The heritage properties and houses located at the lowest point of Middle Harbour Rd will be blocked directly sunlight from the north ,east ,west all day by the proposed develop large building (over 30 meters high and over 100 meters wide) located at the north highest point. The reasons why I strongly oppose this development plan are as follows:

1. Non-Compliant Shadow Impacts

Source Document: Clause 4.6 (Appendix P)Report Fig.6 (Solar Study)

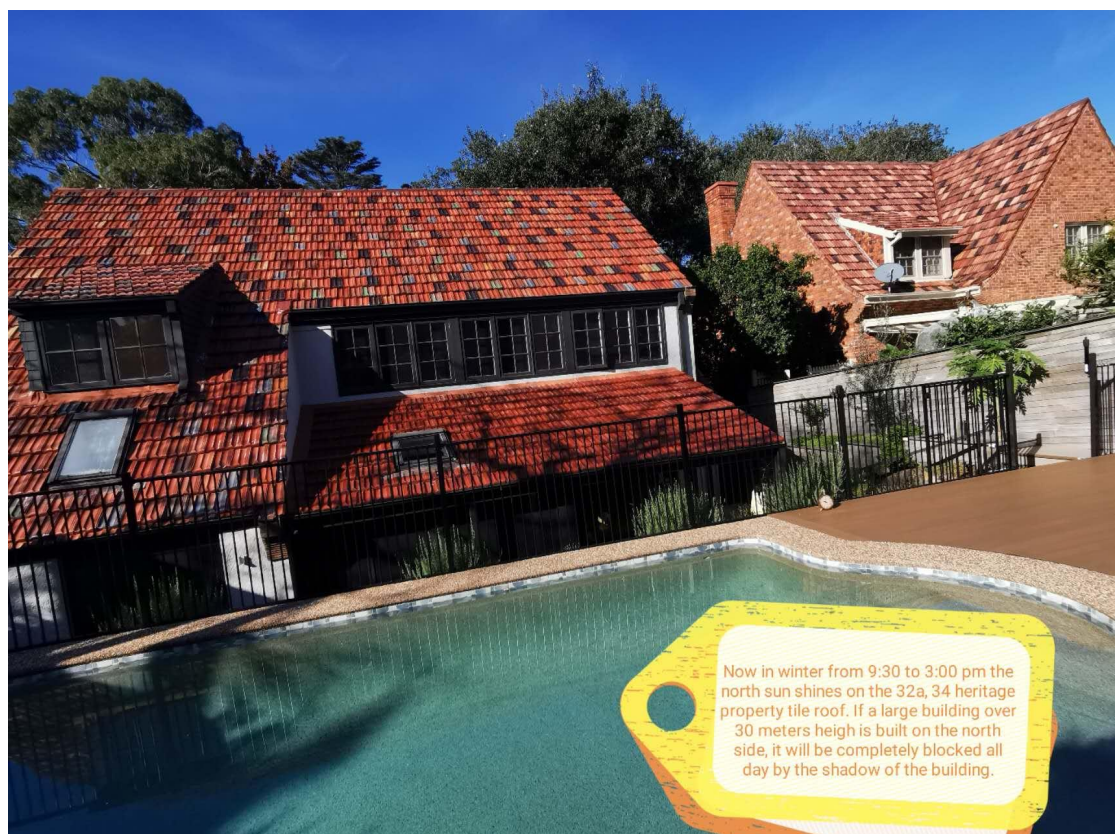
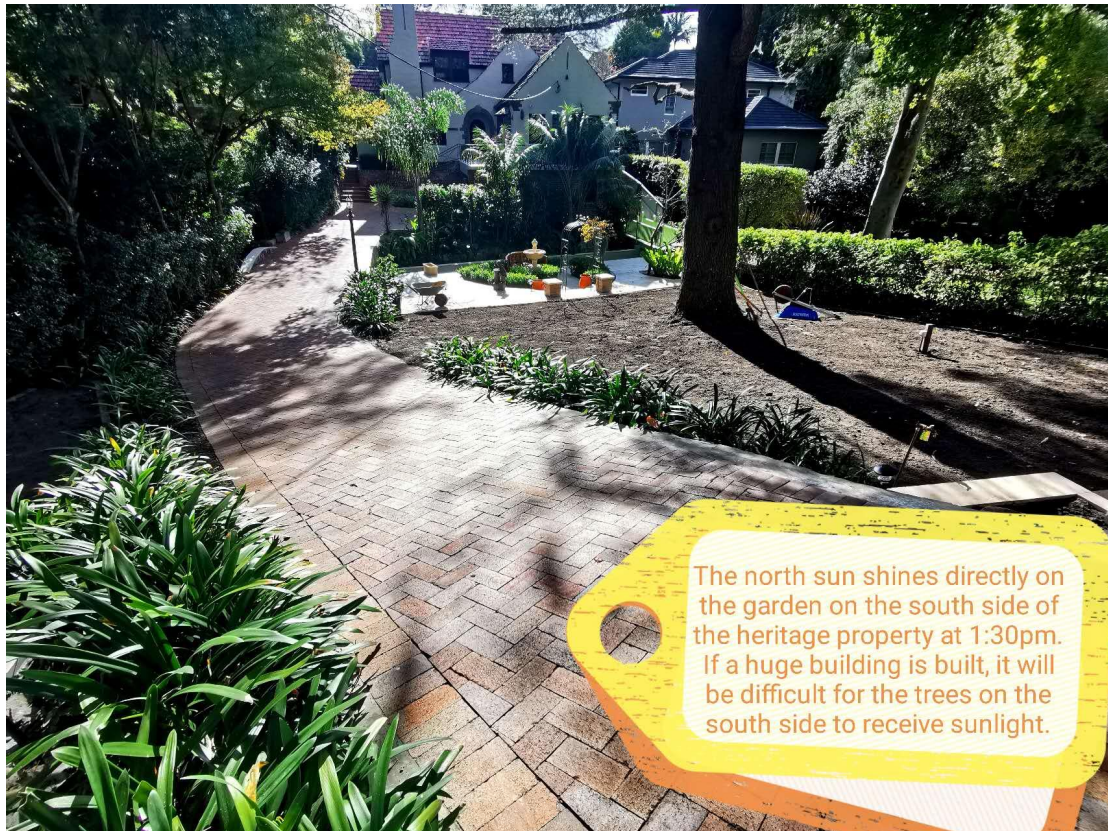
- a) Analysis only covers June 21 (day before winter solstice), ignoring year-worst scenario (June 22 solar altitude 0.5° lower).
- b) Simply mentioning that sunlight reaches the house, deliberately avoiding the regulatory requirement of “direct sunlight between 9am and 3pm on 21st June is to be maintained to the living rooms, primary private open spaces and any communal open spaces”

Recalculation using developer’ s data: Direct sunlight at 34 living rooms drops from 6 hours to less than 1 hour in winter. The main north-facing living space of 55 Trafalgar Ave,30,32,32A Middle Harbour Rd completely loses direct sunlight from 9 am.

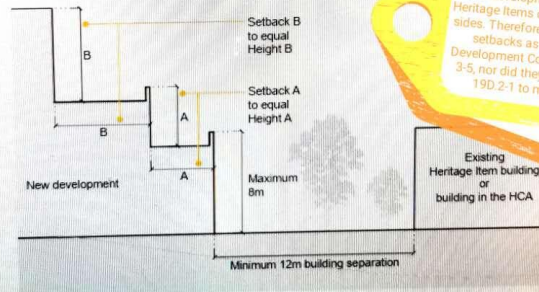
The development project is adjacent to Heritage Items on the north, east and south sides. Therefore, they did not make greater setbacks as required by Ku-ring gai Development Control Plan 2024 Figure 7A 3-5, nor did they follow the provisions of 19D.2-1 to make further setbacks.

Figure 7A.3-5:
On steep sites adjoining lower density zones,
setbacks may need to be more generous.

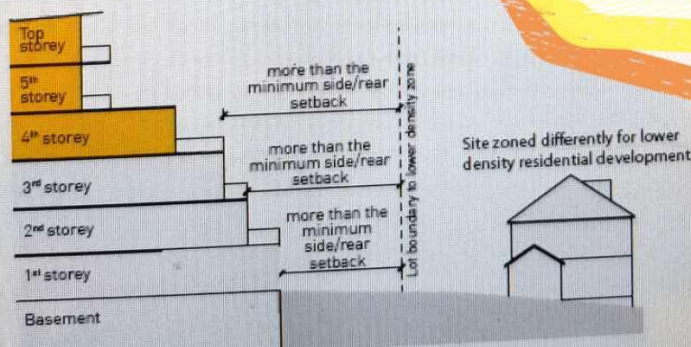
According to the regulations here, the developer's design is completely inconsistent with the regulations. All our heritage properties are downhill, and the development buildings should be set back a certain distance on each floor.

Source Document: HIS(Appendix J) & Clause 4.6 (Appendix P)Report Fig.4

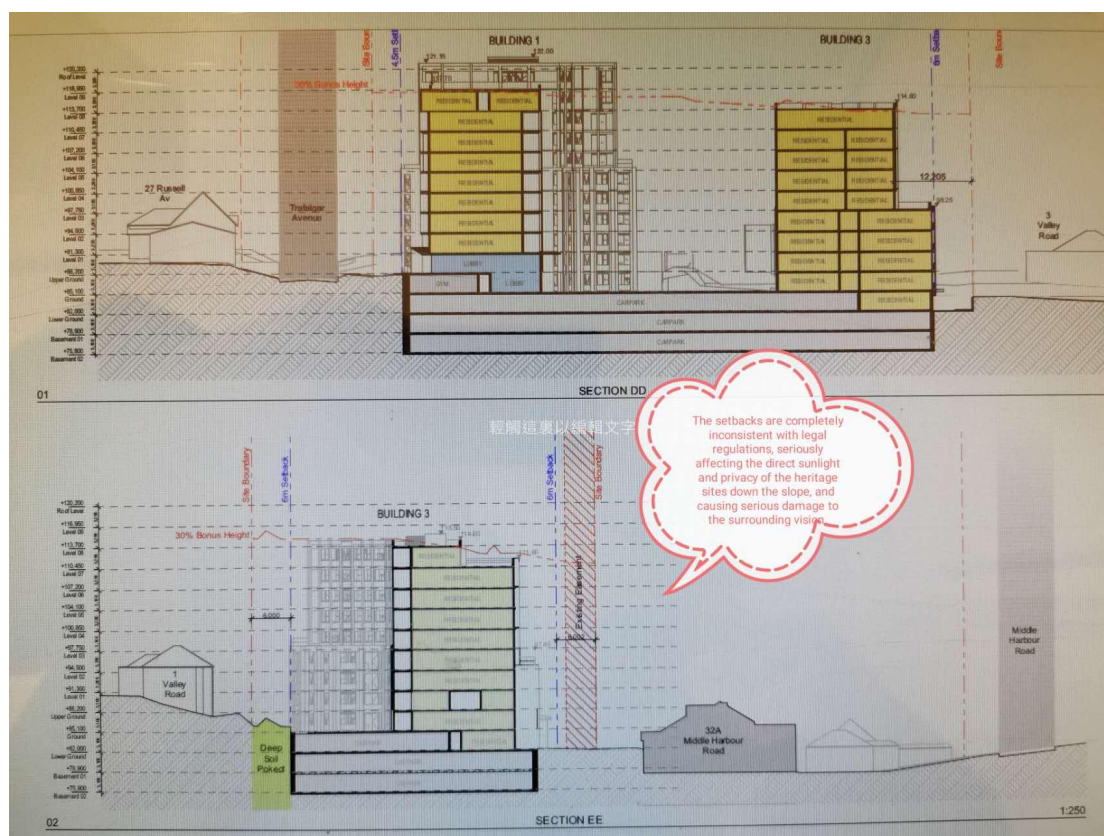
The entire text of HIS (Appendix J) contains no statement at all about the impact of reducing the impact on Heritage Items 32A (1453) & 34 (1452) Middle Harbor Rd. In fact, the negative impact of the proposed development on the above two Heritage Items is devastating in all aspects. The proposed development deliberately avoids this major impact issue.
